## $\frac{\text{MONTGOMERY COUNTY HISTORIC PRESERVATION COMMISSION}}{\text{STAFF REPORT}}$

Address: 20 W. Kirke St., Chevy Chase Meeting Date: 6/11/2025

**Permit No.:** 1116733

**Proposal:** Hardscape alterations and fence installation

Figure 2: Proposed site plan and key. Yellow arrows point to the areas of new work. Blue arrows point to the hardscaping approved under HAWP 1109308 at the April 9, 2025 HPC meeting.

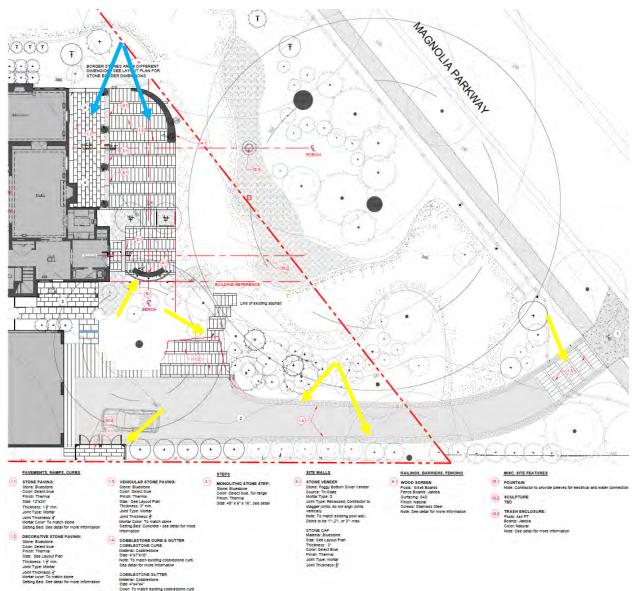
The applicants propose to replace portions of the asphalt driveway with new decorative stone paving, and to install a new wood trash enclosure and six-foot tall wood screen wall. The proposal also slightly reduces the footprint of the previously-approved patio and shape of the southern seat-wall. A portion of the proposed work falls within the Chevy Chase Village-designated right-of-way.

Figure 4: Detail of the site plan from HAWP 1109308, approved by the HPC in April 2025 (left) and detail of the current proposal (right).

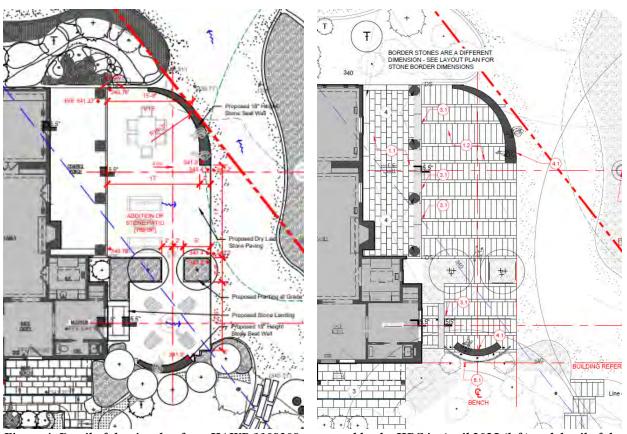
The HPC approved restoration of the enclosed porch to its original, open appearance and construction of a bluestone patio and seat walls under HAWP 1109308 at its April 9, 2025 meeting. The current proposal slightly reduces the footprint of the patio by two feet (from 19 feet to 17 feet) on the east side, as well as on the southern end so that the proposed screen wall will align with the plane of the house. Staff finds that the proposed changes are minimal and in keeping with HPC's April 2025 approval, and will not substantially alter the visual character of the site and surrounding district, per Chapter 24A-8(b)(2) and (d) and *Standard* 9.

Figure 4: Plan and elevation of the proposed wood screen.

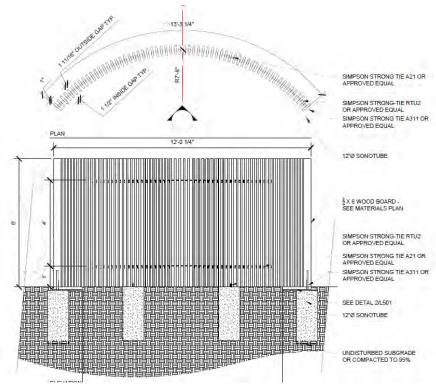
The proposed 13-foot 3 1/4-inch long by 6-foot tall, curved wood screen would be constructed of vertical 5/4-inch x 6-inch wood boards connected with steel fasteners and mounted onto 12-inch sonotube footings. Staff finds that the proposed screen could qualify as a "garden structure," identified in the Design Guidelines as being subject to moderate scrutiny if visible from the public right-of-way. Staff finds that, although the feature may be visible from the public right-of-way, it will be set back substantially to the street, will not destroy or obscure any historic materials, will be compatible with but differentiated from the old, and could be easily removed in the future, leaving the essential form and integrity of the property unimpaired, in keeping with *Standards 9* and *10*. Likewise, staff finds that the proposal will not substantially alter the exterior features of the resource, per Chapter 24A-8(b)(1).

Figure 5: Detail of the driveway paving modifications. The dashed red line indicates the property line. The area outside of the line is within the right-of-way.

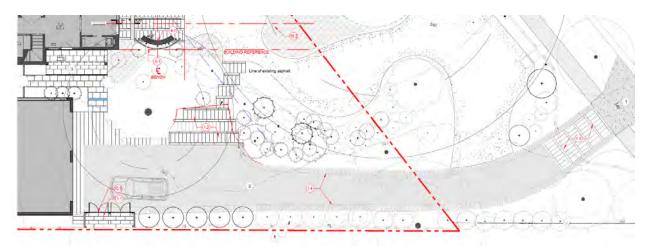
Staff finds that, per the *Design Guidelines*, driveways should be subject to strict scrutiny only with regard to their impact on landscaping, particularly mature trees, but in all other respects should be subject to lenient scrutiny. Staff notes that some pavement replacement is proposed within the dripline of two mature trees adjacent to the driveway and that the application includes a demolition and tree protection plan that includes root pruning and tree protection measures. Staff recommends that the applicants consult with an arborist regarding the proposed scope and implement the arborist's recommendations for tree protection. Other portions of the proposed driveway replacement fall within the Chevy Chase Village-designated right-of-way. Provided mature trees are adequately protected and the scope is approved by or does not require review by Chevy Chase Village, staff supports the replacement of portions of the asphalt driveway with cobblestone and bluestone paving as proposed, as well as the replacement of existing stone pavers with new pavers in a modified footprint and configuration. Staff finds that the proposed alterations do not remove or damage historic materials and that the proposed materials are compatible with the historic resource, per *Standards 2* and *9*, and Chapter 24A-8(b)(2), as well as the *Design Guidelines*.

1. The applicant must consult with and implement the recommendation(s) of an arborist regarding the tree protection plan prior to issuance of the HAWP.

Figure 7: Trash enclosure elevation and section drawings.

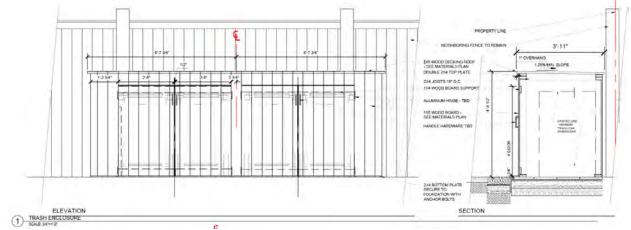
Along the southern property line, adjacent to the garage, the applicants propose to install an approximately 13-foot long by 4-foot deep by 4-feet 8 1/2-inch tall wooden trash enclosure clad in 1-inch by 5-inch vertical wood boards. Staff finds that the proposed location is inconspicuous from the public right-of-way, does not destroy or obscure any historic materials that characterize the property, could be removed in the future without damaging the historic resource, and is compatible in design and materials with the historic property, in keeping with *Standards* 2, 9, and 10 and Chapter 24A-8(b)(1) and (2).
